MKM
architecture + design

Project 25009 – Daniel’s Place Respite Care
New Construction: 639 North Market St., North Manchester, Indiana, 46926

ADDENDUM No. 2

December 09, 2025

E-201

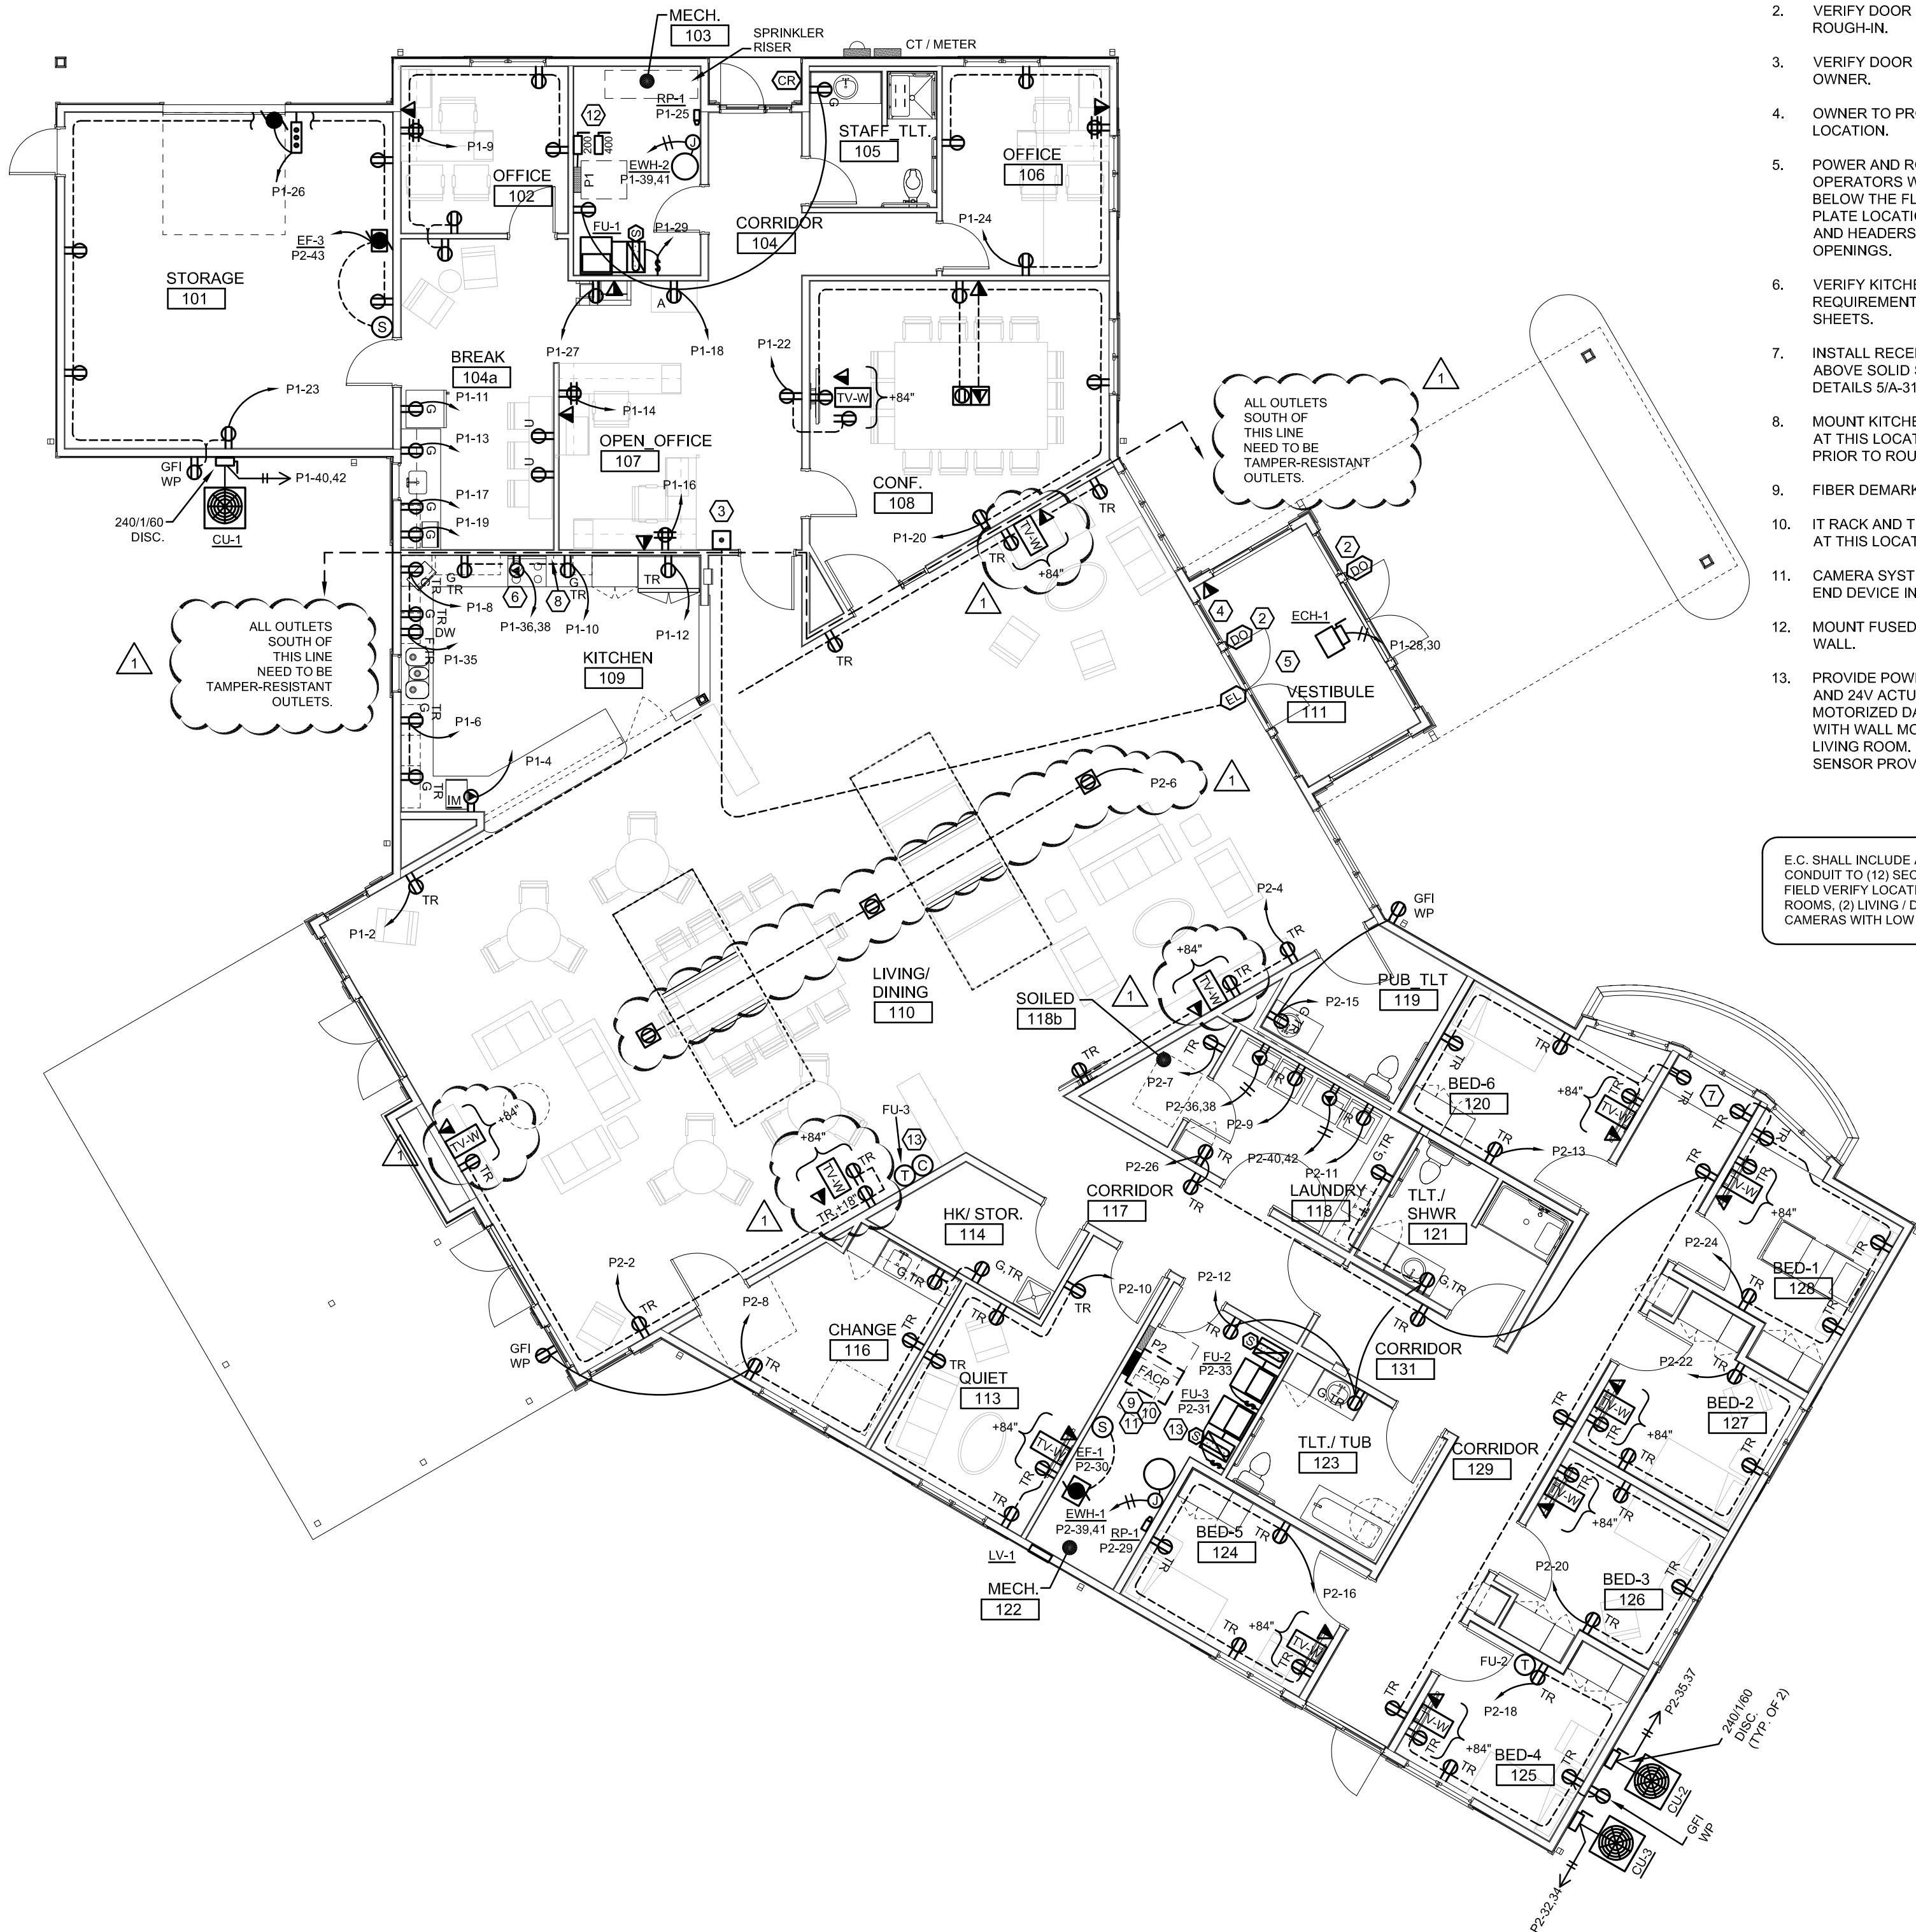
- 14. Sheet E-201 – First Floor Power Plan**
 - a. Clarification: See attached revised sheet for added TV locations in room #110.
 - b. Clarification: See attached revised sheet with addition of floor box locations in room #110.

- c. Clarification: See attached revised plan for note clarifying tamper-proof outlet locations.
- 15. Sheet E-401 – Electrical Schedules & Details**
 - a. Clarification: See attached revised sheet for revision to the electrical symbol Legend.
